# TEATICKET GOLF COURSE

LITCHFIELD, CONNECTICUT

## Environmental Review Team Report

August 1997

Figure 3

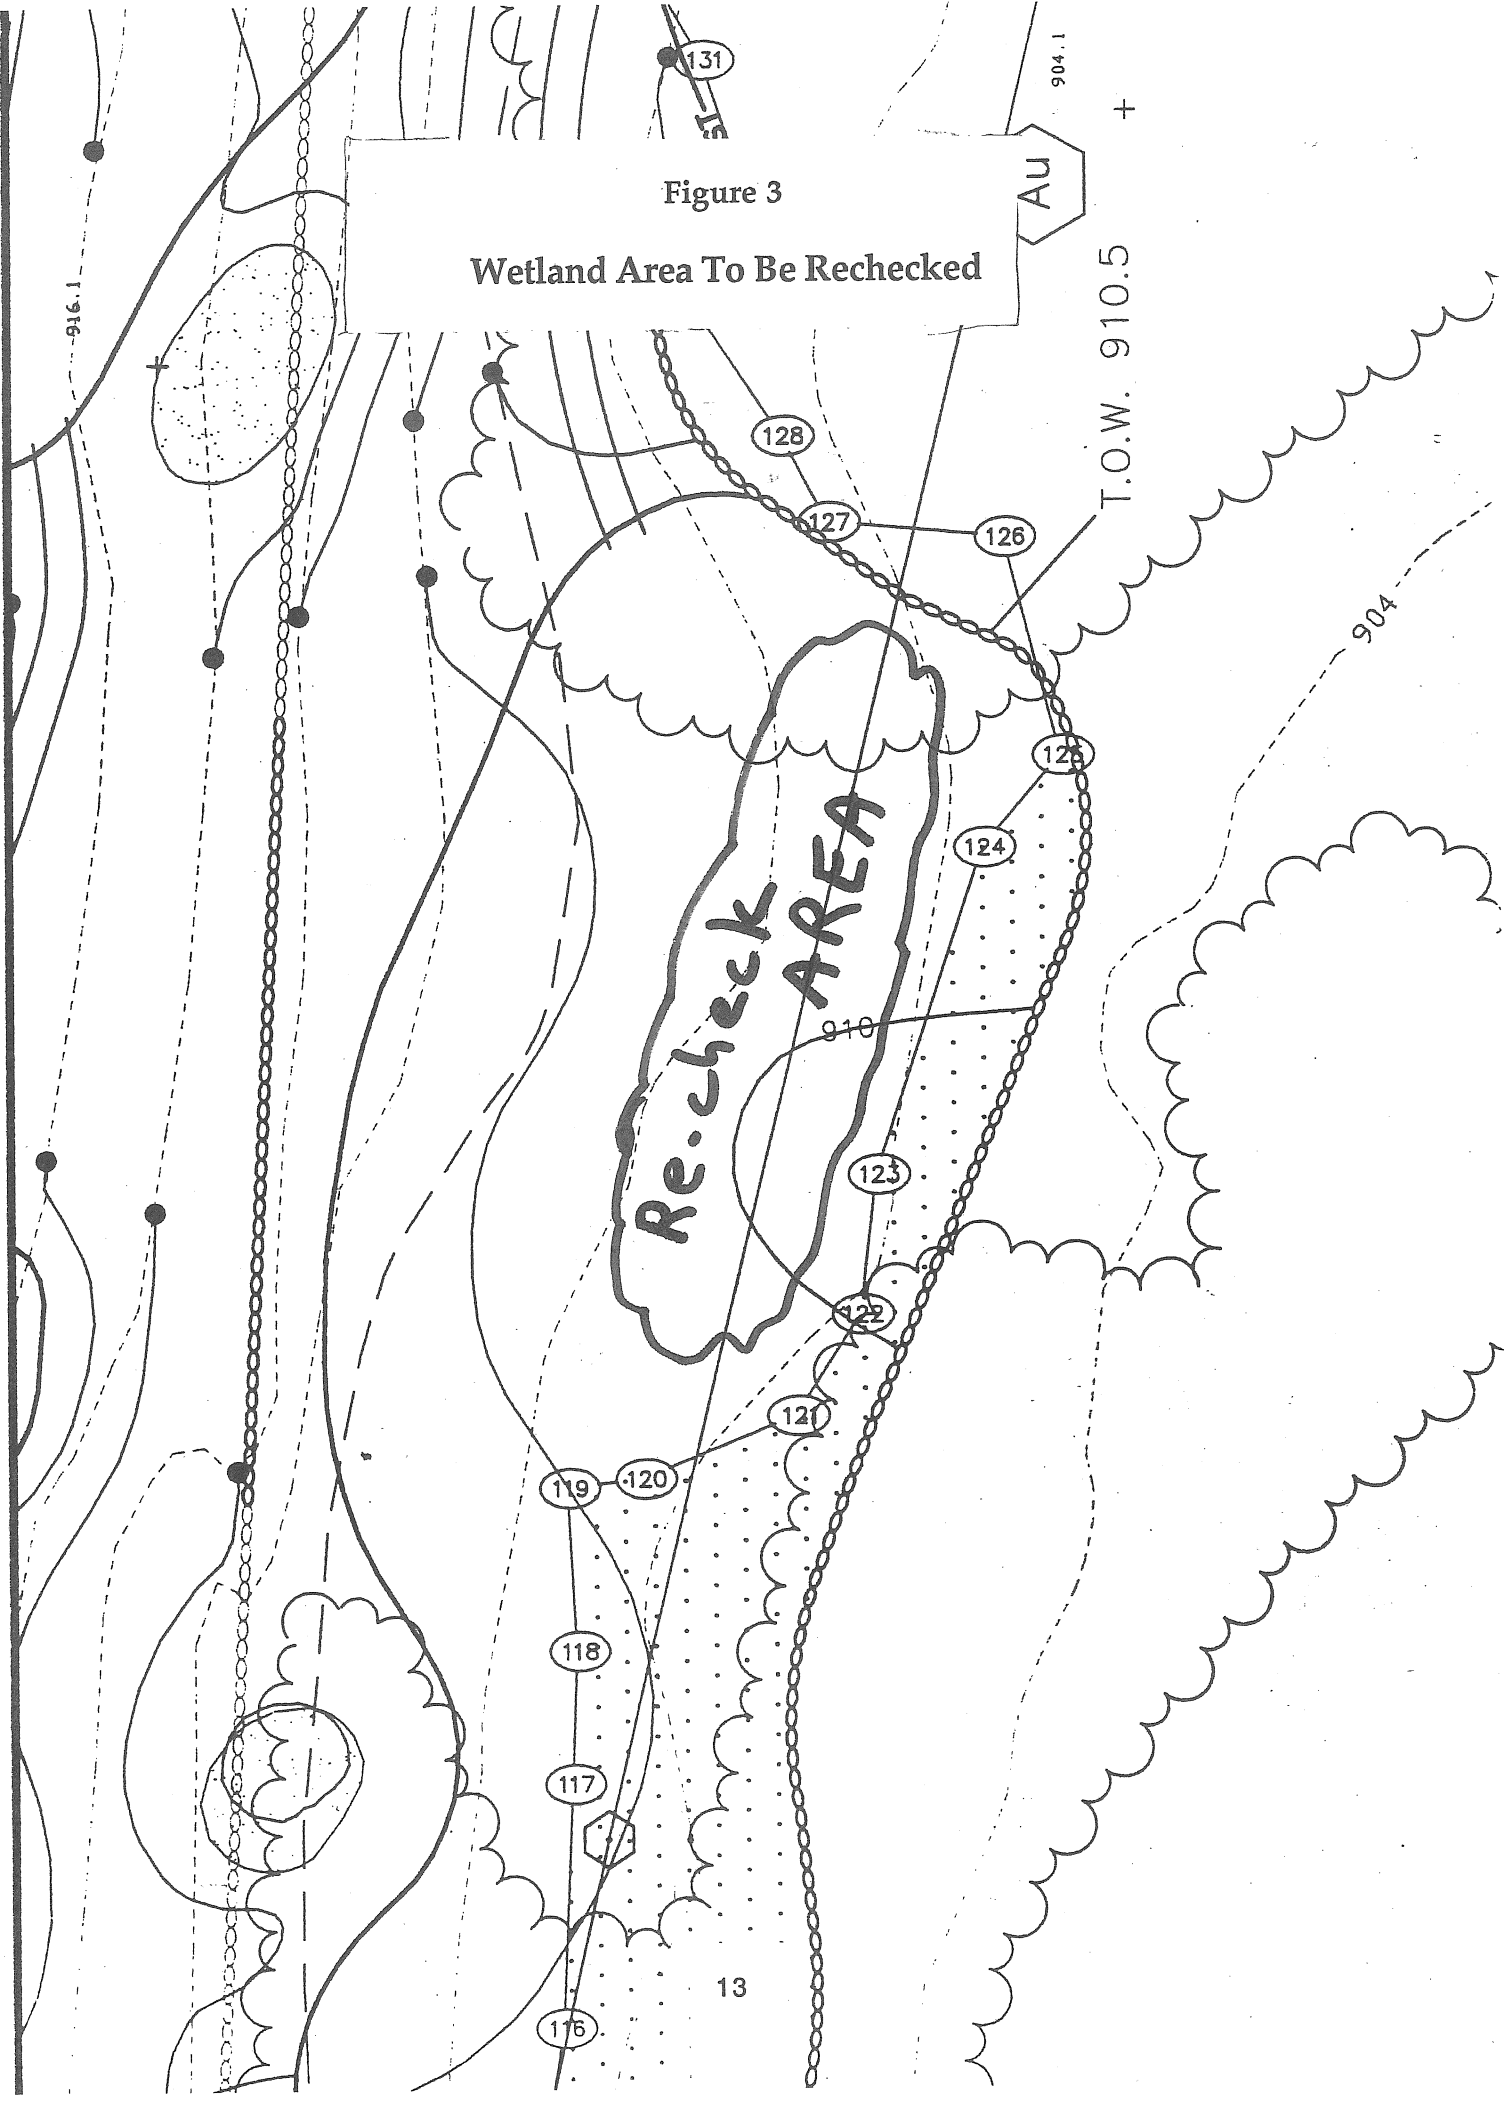
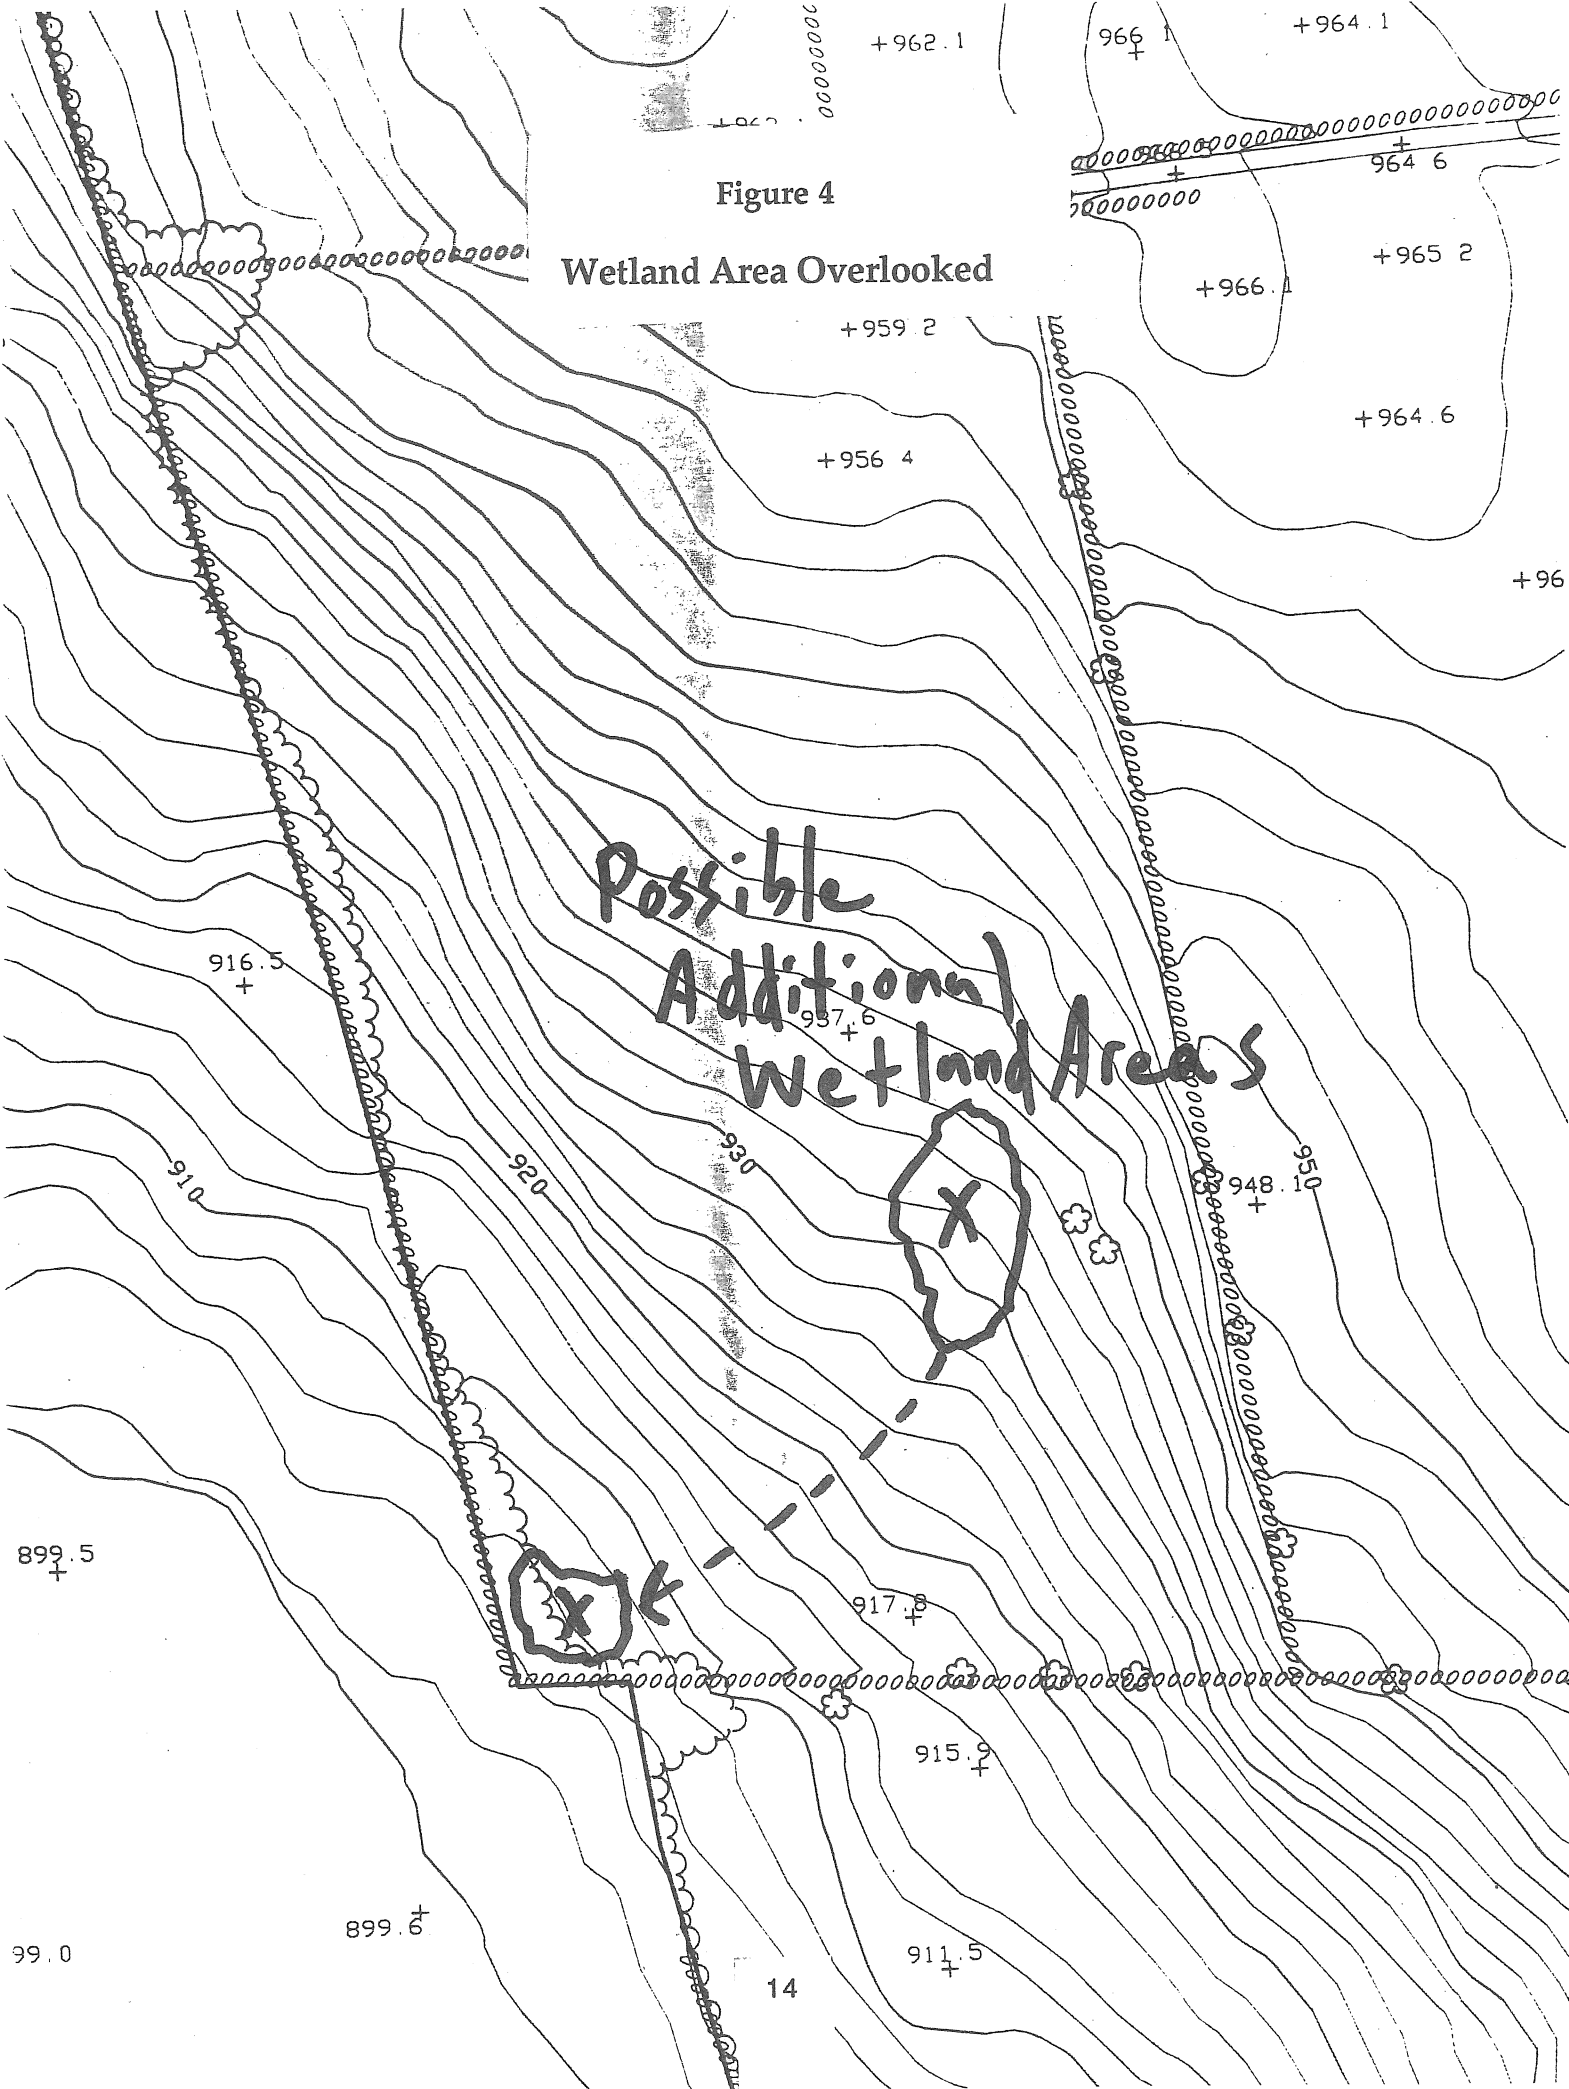
A detailed and representative description of on-site wetlands is contained within the document entitled "Draft #1" which was distributed by consultants for the developer prior to our 3/15/97 site walk. The Team wetland specialist is assuming that the author is Penelope C. Sharp, one of the developer's environmental consultants. Approximately 31 acres of the 147-acre horse farm (21%), have been determined to contain predominately wetland soils as a result of detailed site inspections by the developer's soil scientist. During the ERT site walk, the wetland specialist noted an area outside of the wetland boundary, between wetland flag numbers #119 and #127 (west of the eighth tee), which should be re-checked by the project soil scientist for possible boundary relocation. There is also one complete wetland area that appears to have been overlooked in the vicinity of the third fairway leading down to the thirteenth fairway. This area consisted of an advanced wet-meadow on the "high-end" of saturation evidenced by the existence of tussock sedges. This wetland appears to be fed via a seep/spring where the ground water breaks out of the slope and flows down in a broad, vegetated swale to the property line where the slope begins to level out (refer to Figures 3 & 4 for a map location of these areas).

The proposed construction of an 18-hole golf course, clubhouse, driving range and associated parking will occupy virtually all of the available upland area as well as 3.2 acres of wetland areas of this property. This figure of direct, permanent impacts was derived by the wetland specialist Team member in contrast to the 2.8 acre figure derived by the developer. This discrepancy of 13% can be attributed in part to two factors: 1) the Team member slightly enlarged some impact areas assuming that impact would include all areas within the proposed sediment control barrier, and 2) a fill area was not accounted for in the vicinity of wetland flags 252-257 at the twelfth tee area.

Figure 6

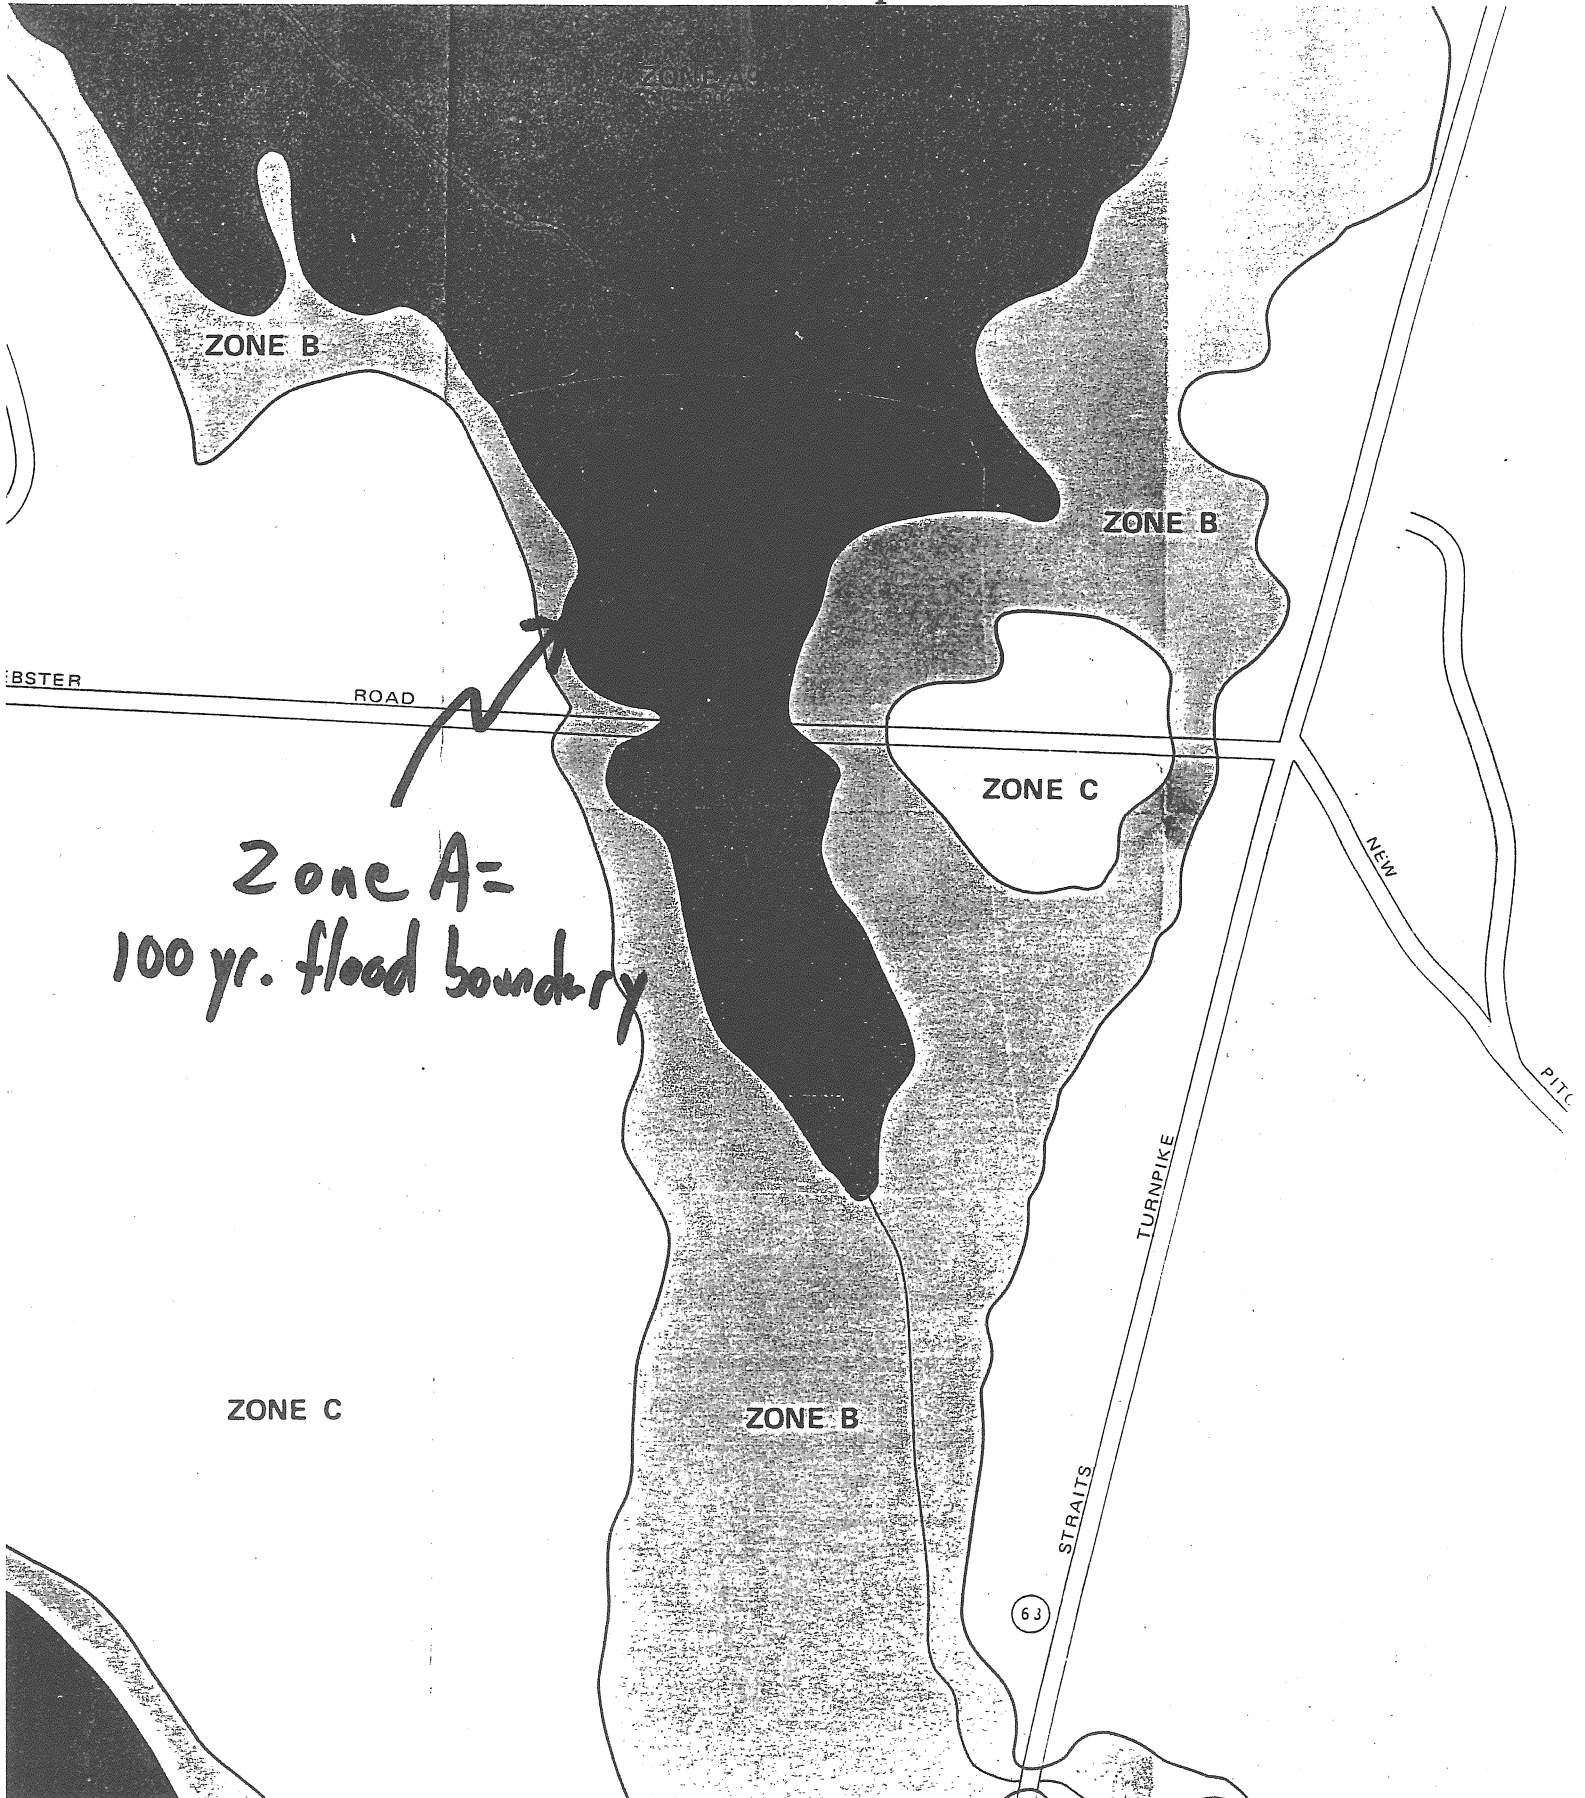
Maps on file in this office indicate the existence of a FEMA 100- year floodplain boundary (Refer to Figure 6 for a copied portion of the FEMA map of this area). It appears that areas of fill are proposed within this bounded area. The developer should contact the municipal planning and zoning agency to apply for a Floodplain Permit should this project progress.
